**STAFF PAPER**

# **Review of Los Angeles Department of Water and Power's 2017 Power Integrated Resource Plan**

September 2019 | CEC-200-2019-015

**Figure 1: LADWP and CEC Energy Forecasts 2018-2030 (GWh)**

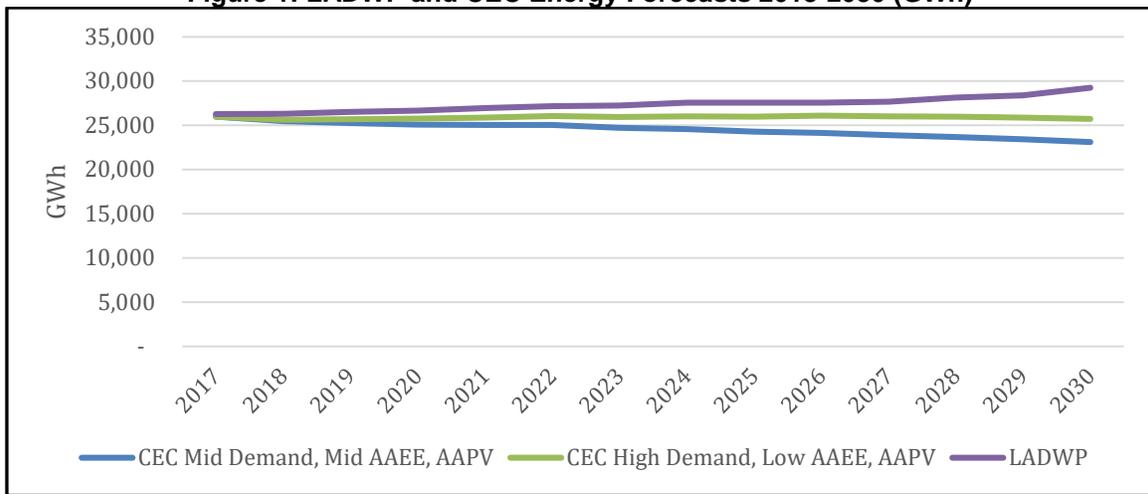
The CEC’s energy demand forecast for LADWP in the high demand case (low AAEE and AAPV) remains relatively flat over the forecast periods,<sup>9</sup> while the mid demand case (mid AAEE and AAPV) decreases.<sup>10</sup> Both CEC forecasts are lower than LADWP’s forecast as shown in **Figure 1**.

**Figure 2: LADWP and Energy Commission Peak Forecasts 2018 — 2030 (MW)**

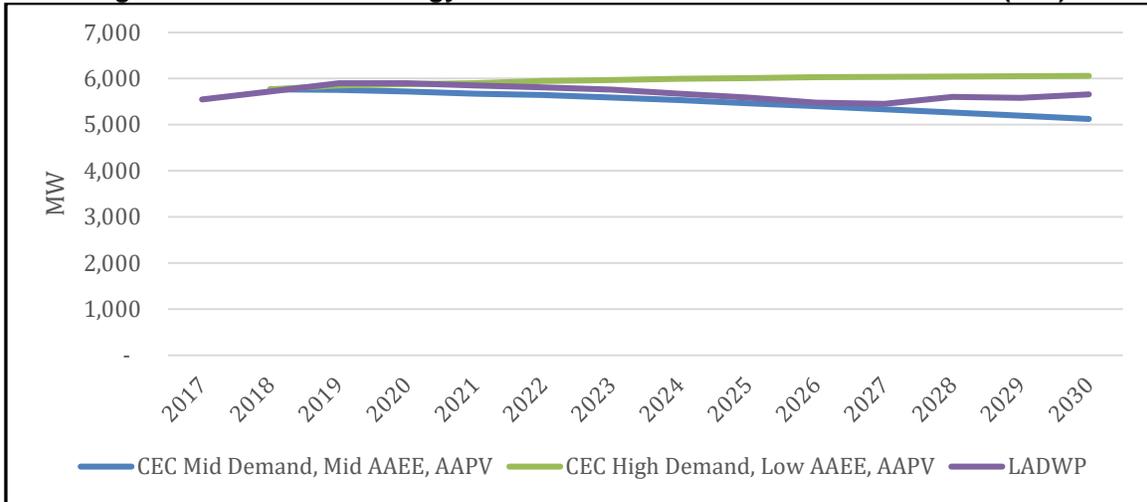
Figure 2 shows a comparison of LADWP’s peak demand forecast with the CEC’s forecasts. The CEC’s high demand forecast (low AAEE and AAPV) is relatively flat over the forecast period, while the mid demand case (mid AAEE and mid AAPV) shows a modest decline. For this figure, LADWP’s forecast falls between the CEC’s two cases.

**Figure 3: Sources of Renewables Portfolio Standard Eligible Energy 2019 — 2030 (MWh)**

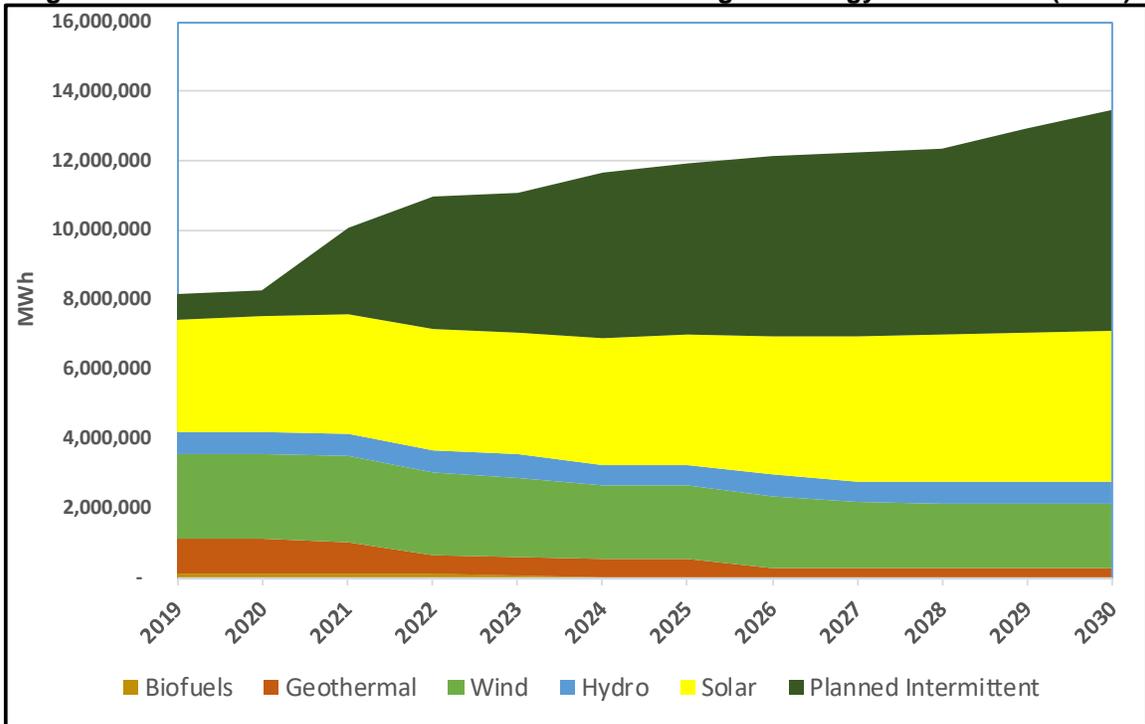
**Figure 3** shows how LADWP's renewable portfolio will evolve and grow over the forecast period.

Existing geothermal production decreases substantially in 2022 due to the expiration of the contract with Hudson Ranch facility. Biofuels cease to be a part of LADWP's portfolio in 2024 when the power purchase agreement for this expires. By 2030, nearly half of LADWP's renewable portfolio will be made up of new planned renewable resources (mostly in the form of solar and generic renewables).

**Figure 4: LADWP Renewable Portfolios in 2019 to 2030**

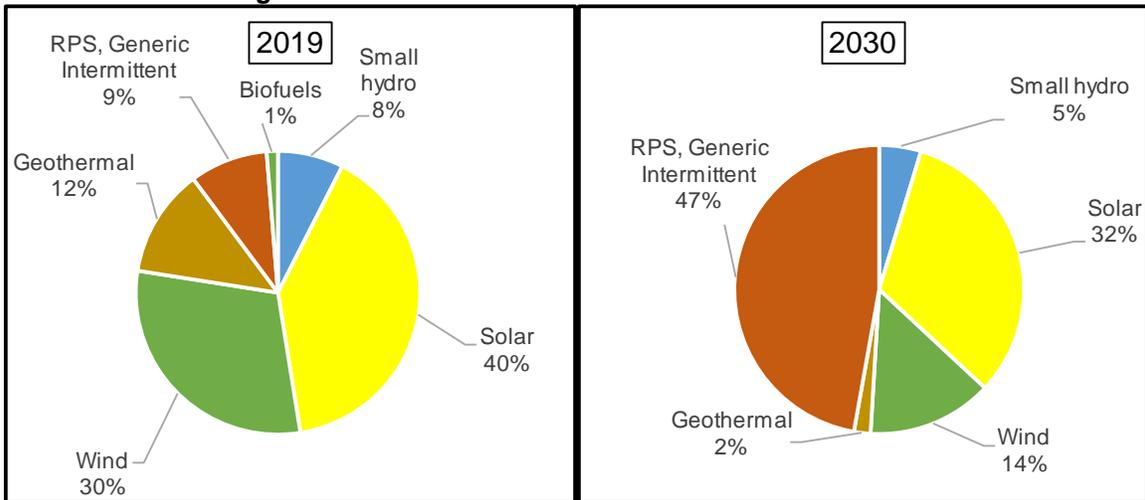
Planned intermittent renewables in the form of wind, solar, and geothermal will ramp up significantly starting in 2020. Existing wind and geothermal resources will decrease slightly over the forecast period. **Figure 4** shows how the renewable portfolio of 2019 compares with the projected renewable portfolio of 2030.

**Figure 5: LADWP Portfolio Comparison for 2019 and 2030**

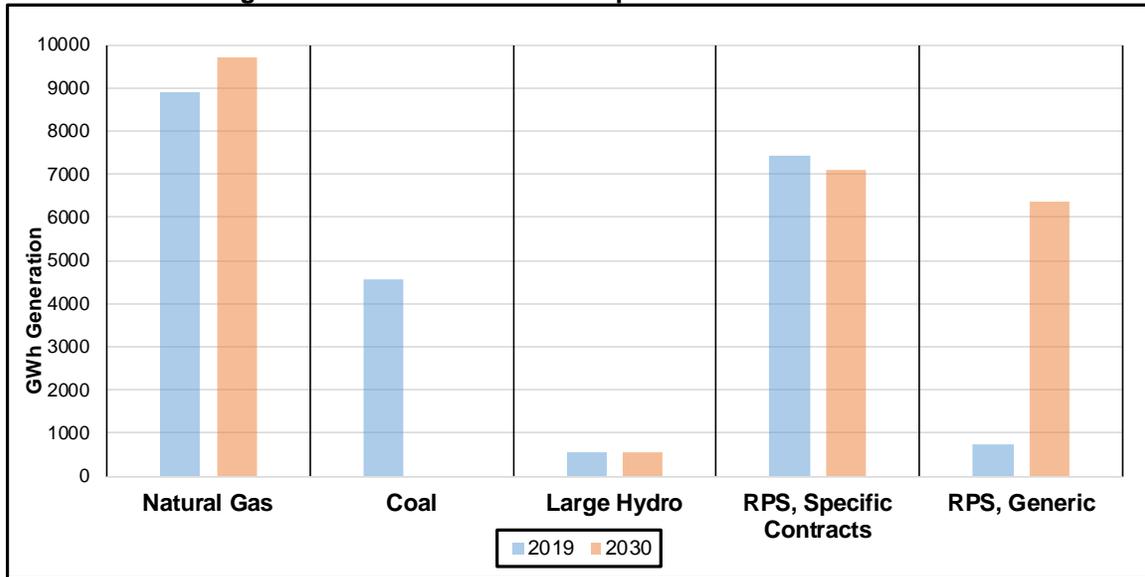
PUC Section 9621(d)(1)(D) requires that POUs address the procurement of a diversified portfolio of resources consisting of both short-term and long-term electricity, electricity related, and demand response products. Based on staff's review of LADWP's existing resources, its portfolio analysis, and the selection of resource additions in its IRP, staff concludes that the utility has fulfilled this requirement.

**Figure 5** shows a comparison of the energy mix by resource in LADWP's preferred portfolio in 2019 and 2030.
